THREE MILE ISLAND NUCLEAR STATION, UNIT 1
AMENDMENT TO FACILITY OPERATING LICENSE

Amendment No. 13
License No. DPR-50

ATTACHMENT TO LICENSE AMENDMENT NO. 13

Replace pages 2-5, 2-6, 2-9 and Figure 2.3-1 of the Appendix A Technical Specifications with the attached revised pages 2-5, 2-5a, 2-6, 2-9 and Figure 2.3-1. Changes on these pages are shown by marginal lines.

1555 304
FIGURE 2.3-1

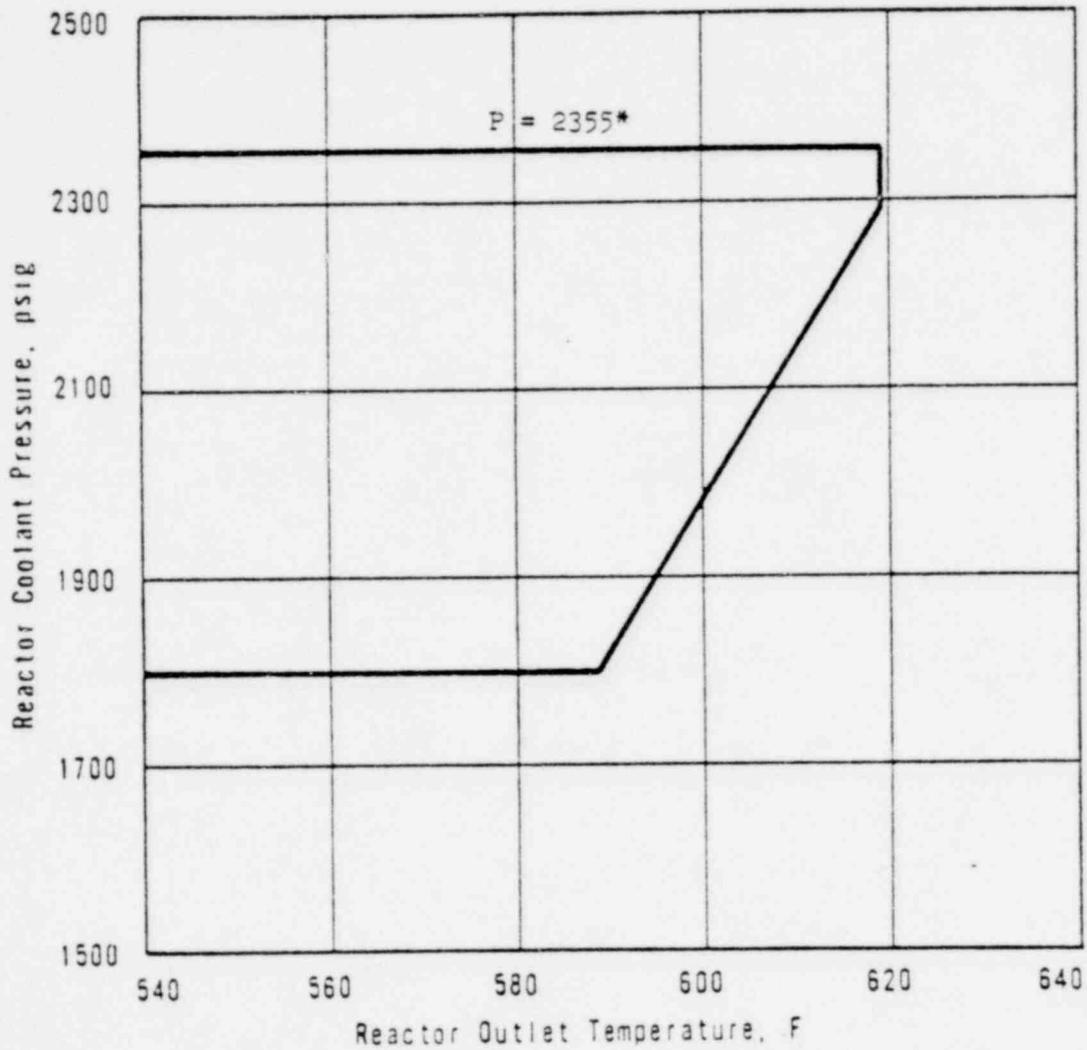
During a startup accident from low power or a slow rod withdrawal from high power, the system high pressure trip set point is reached before the nuclear overpower trip set point. The trip setting limit shown in Figure 2.3-1 for high reactor coolant system pressure (2355*psig) has been established to maintain the system pressure below the safety limit (2750 psig) for any design transient.

- 2.3.1 The reactor protection system trip setting limits and the permissible bypasses for the instrument channels shall be as stated in Table 2.3-1 and Figure 2.3-2.
- 2.3.2 For the 24 hour period prior to Cycle 1 shutdown for refueling the high pressure trip setpoint may be increased to 2405 psig provided that the following precautions are taken during this period.
- a. If pressurizer level exceeds 315 inches as indicated by the high-high level alarm, the reactor shall be manually tripped.
 - b. If the reactor drain tank pressure exceeds 15 psig, the reactor shall be manually tripped.

* Except as specified in 2.3.2
